Wheel Horse

KIT 6058

Wheel Horse Service Bulletins 1961 - 1990: #63 Issued: March 1965

RM-425 Rotary Mowers - Clutching

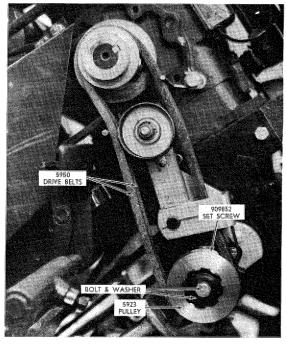
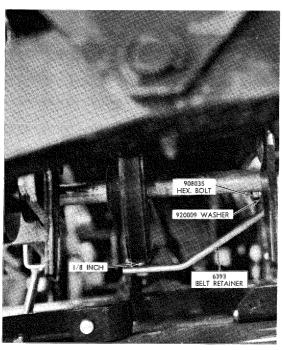
- 1. Remove the #5950 Drive Belts. (Figure A)
- 2. Remove the hex bolt and washer which secure the #5923 Pulley to the #5921 Mower Drive Shaft. (Figure A)
- 3. Remove the #909852 Set Screw from the pulley and remove pulley from the shaft. (Figure A)
- 4. Install the #6394 Pulley and secure by reversing above procedure.
- 5. Remove the rear 5952 Hex Bolt and lockwasher which secure the #5954 Bearing Assembly to the #5907 L.H. Drag Link.
- 6. Place the #920009 Flat Washer on the #908035 Hex Bolt (both supplied in kit) and install the #6393 Drive Belt Retainer, as shown in Figure B. The bolt is inserted from the inside of the frame.
- 7. Position the #6393 Belt Retainer 1/8" from the belt (Figure B) and tighten the bolt. Secure the bearing assembly with the #915663 Nut provided.
